Groundwater & Wastewater Services
Septic Project File & Data Review Worksheet

GWS File #: 7934B WASPS App #: 3901

Re: Application for approval to use an existing on-site wastewater treatment & disposal system.
Property Location: 6020 Wilkinson Boulevard
Health Department file number: **7934B**

INSTALLATION APPROVAL for an
ON-SITE WASTEWATER TREATMENT & DISPOSAL SYSTEM

PROPOSED PLOT PLAN

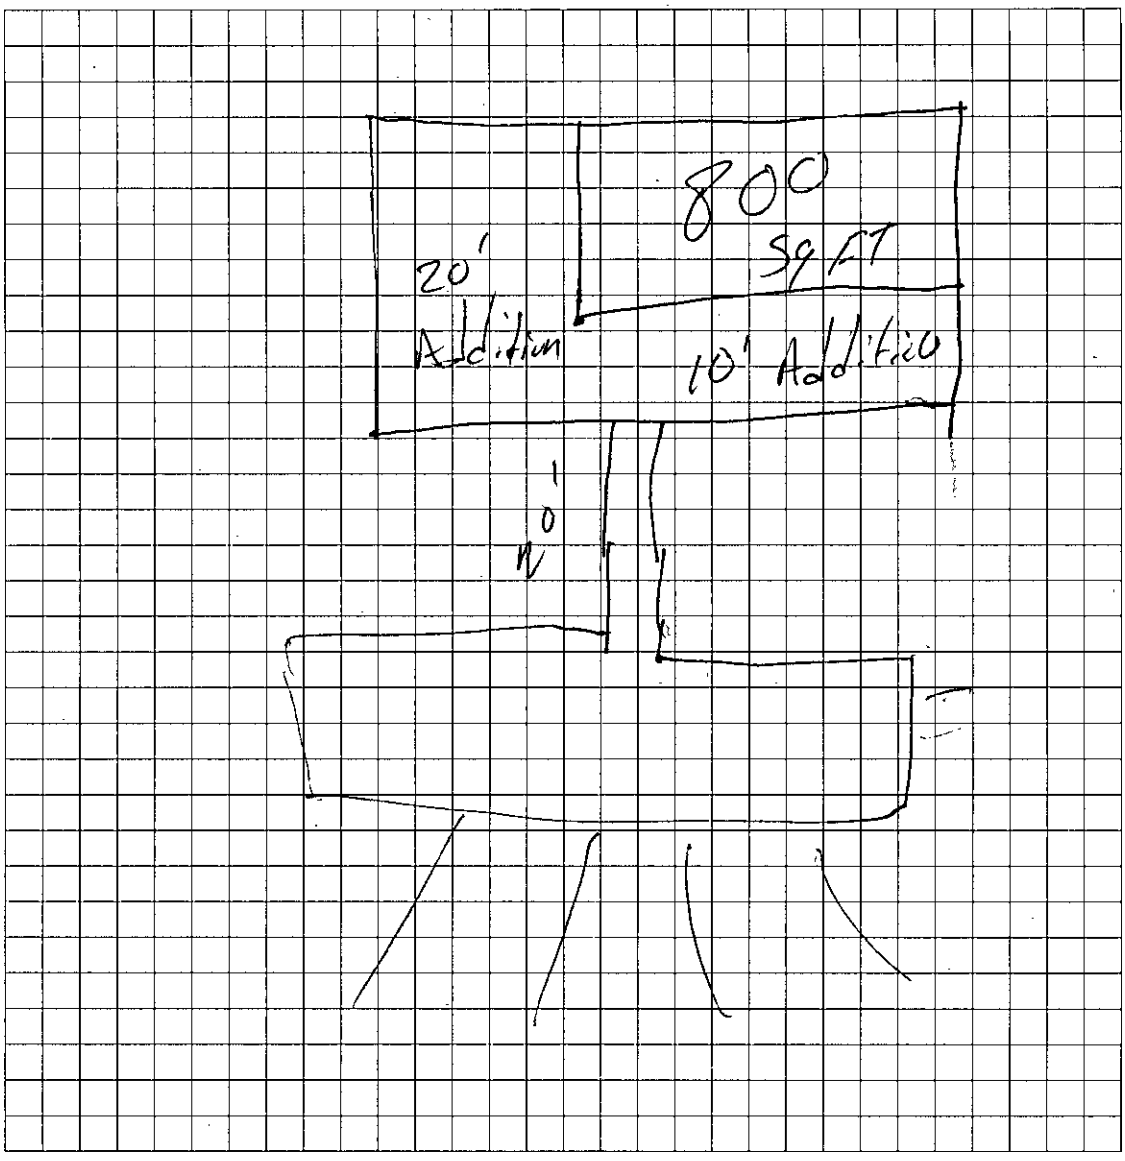
USE EXISTING SYSTEM DENIED DUE TO NOT MEETING REQUIRED SETBACKS IN PROPOSED PLANS, PROJECT WILL EXCEED DAILY DESIGN FLOW.

Based on the information provided in the application, dated October 3, 2008, and findings from the site evaluation conducted by our office, your request for approval to use an existing on-site wastewater treatment & disposal system is **not** being granted. This decision is based on the following conditions that were identified during the site visit:

- ☐ The existing on-site wastewater treatment & disposal system was not functioning properly at the time the site evaluation was conducted.
- ☒ The proposed plans do not meet the required setbacks for the on-site wastewater treatment & disposal system serving the property.
- ☐ The proposed plans do not meet the required setbacks for the reserved repair area for an on-site wastewater treatment & disposal system.
- ☐ The proposed plans do not meet the required setbacks for water supply wells.
- ☒ The proposed project will exceed the permitted daily design flow for the existing on-site wastewater treatment & disposal system. System alteration will be required in order to accommodate your proposed project.

SKETCH OF SYSTEM LAYOUT
(Proposed Layout)

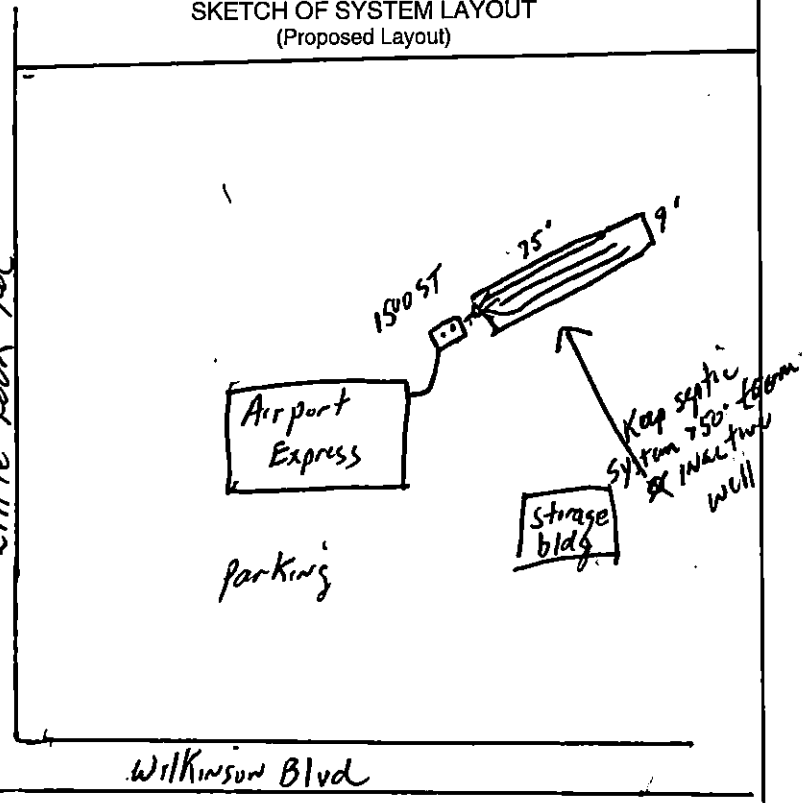
Comments: System Classification & Type: Type IIIg, Repair, Install 1500 ST & Install Bed System 9'wd @ 75'long @ 36" Tire Chips Keep septic system >50' from existing Neighbors well
